केन्द्रीय चिड़ियाघर प्राधिकरण  
**Central Zoo Authority**  
(STATUTORY BODY UNDER THE MINISTRY OF ENVIRONMENT & FORESTS, GOVT. OF INDIA)

**Sub:- Development of Kurumbapatti Zoological Park, Salem - Regarding.**

The proposed designs for the construction of animal enclosures at the Kurumbapatti Zoological Park, Salem were placed before the 5<sup>th</sup> Meeting of the Expert Group on Zoo Designing held on 15<sup>th</sup> July, 2008 and the following observations are being made:—

**DRAWING NO:5  
PROPOSED ENCLOSURE FOR  
MARSH CROCODILE**

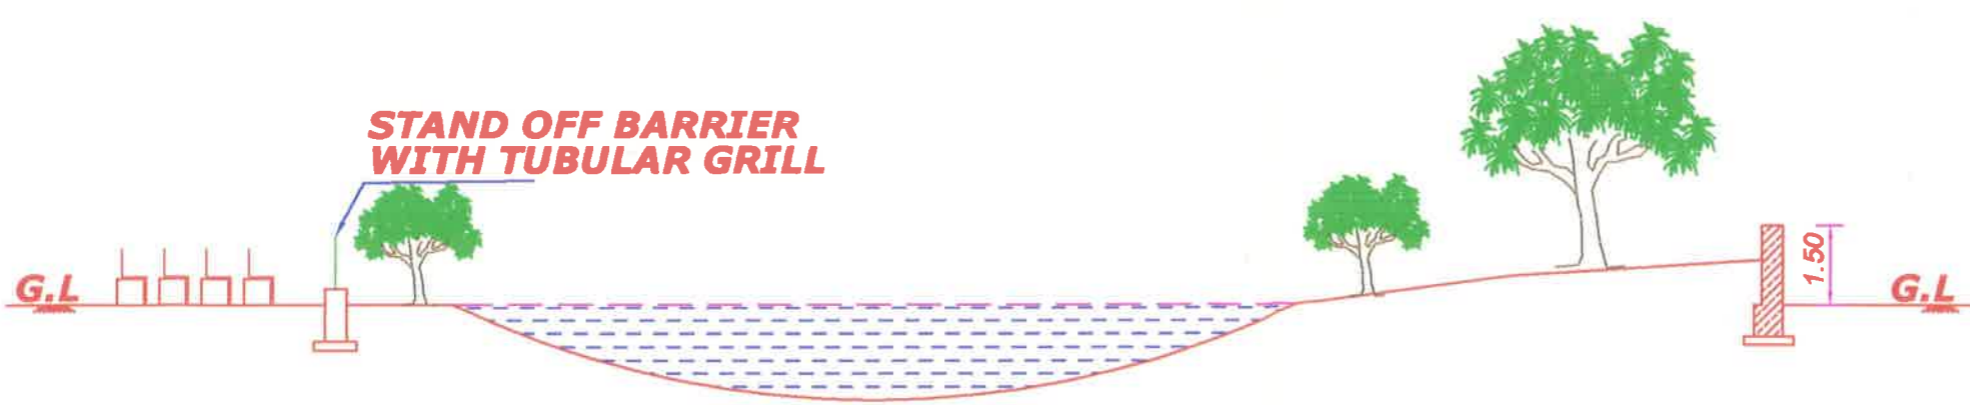
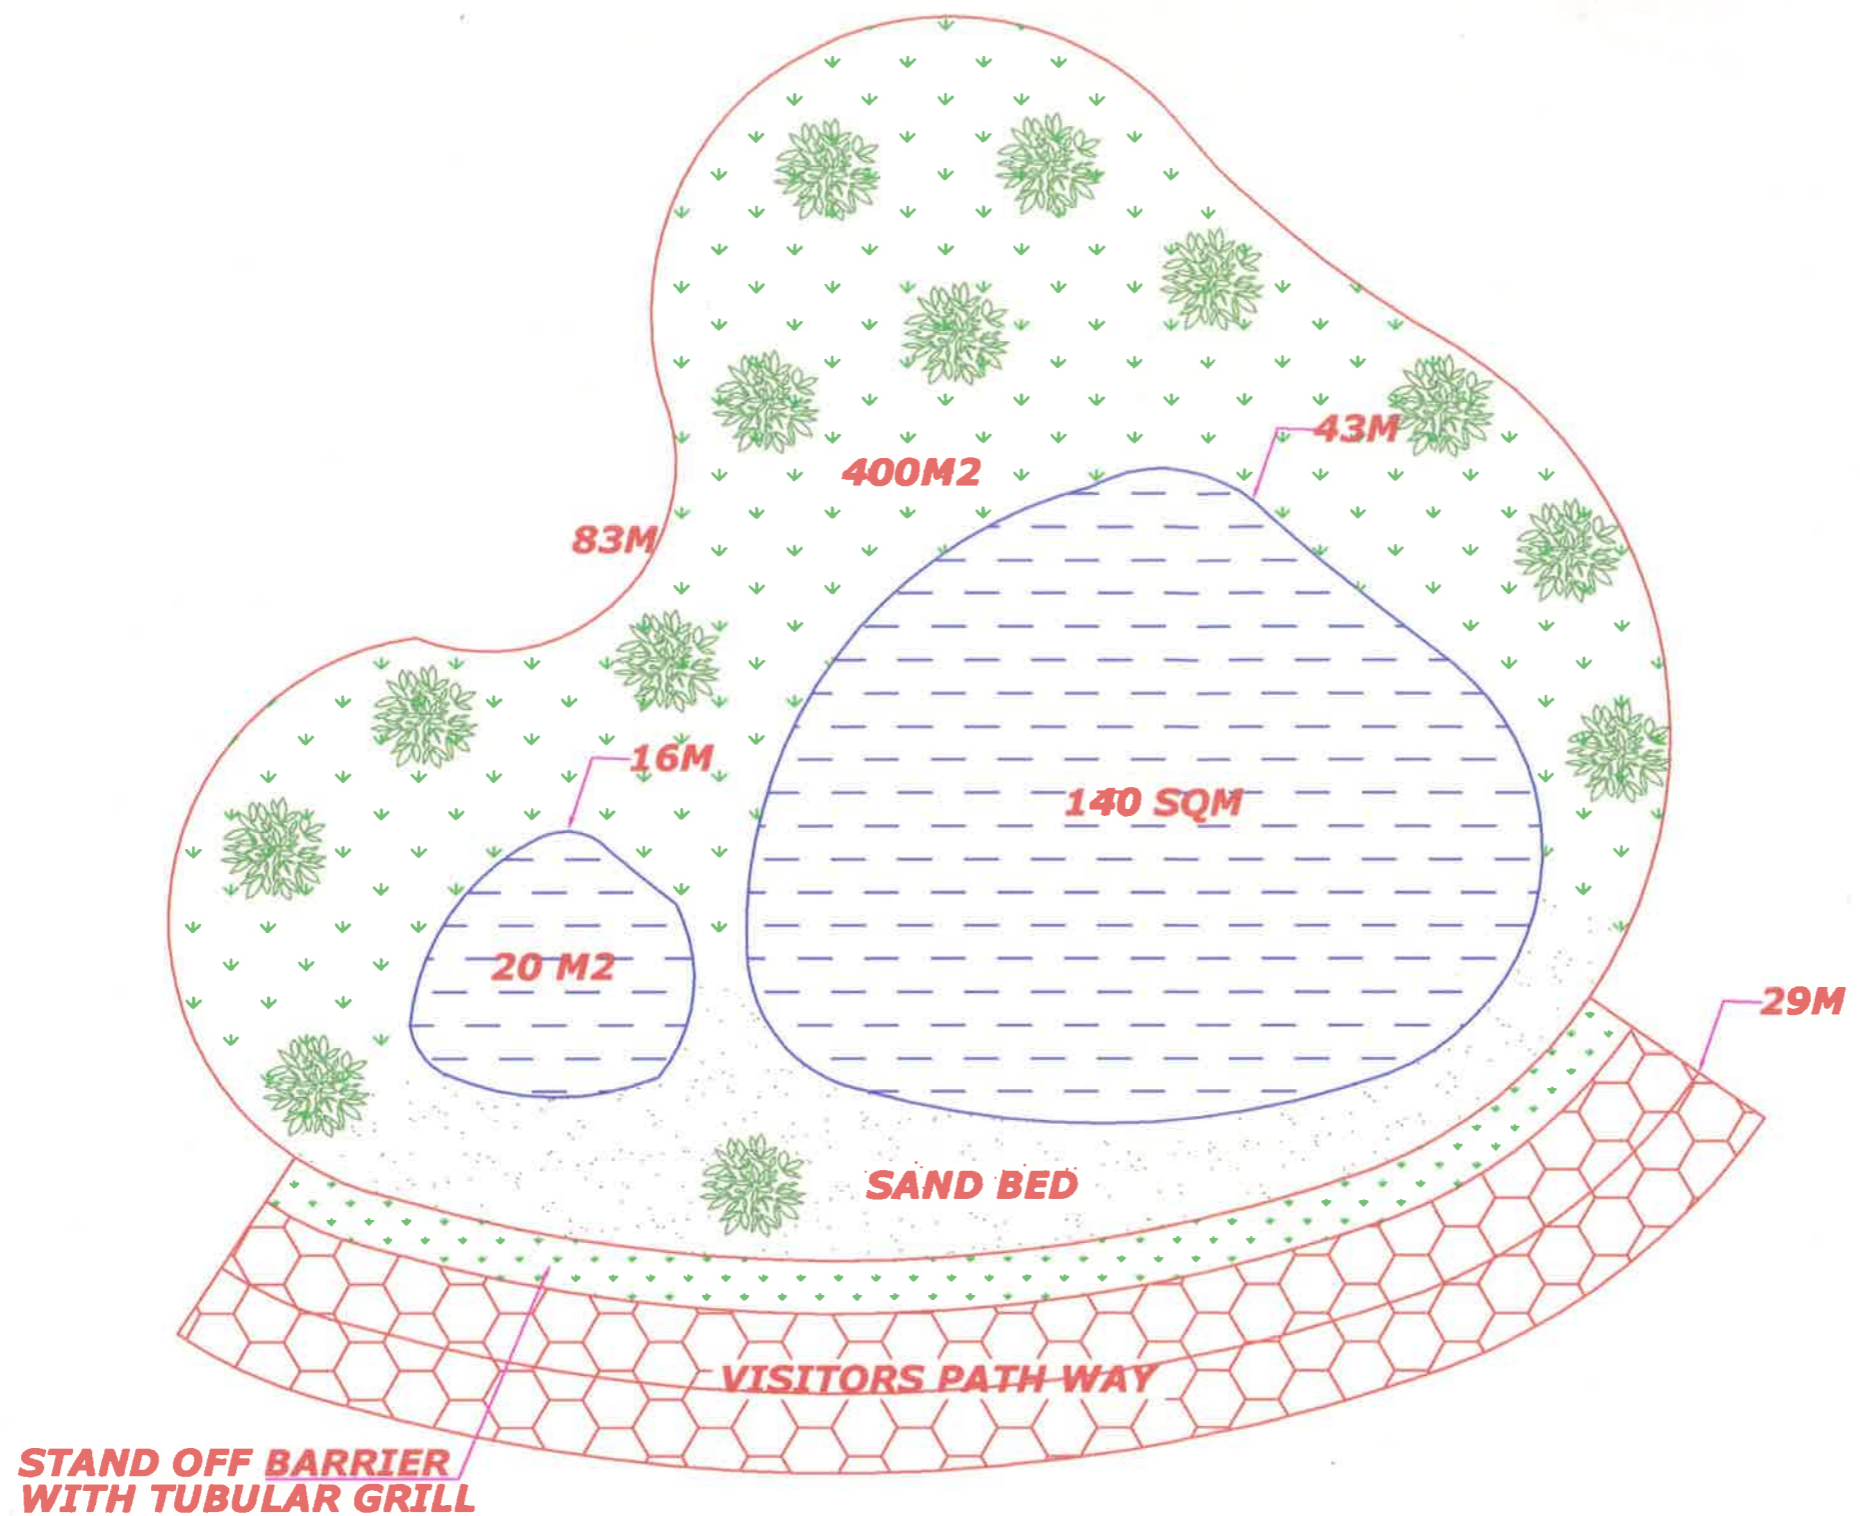
**(iii) Revised design for the construction of enclosure for Marsh crocodile**

The design was approved.
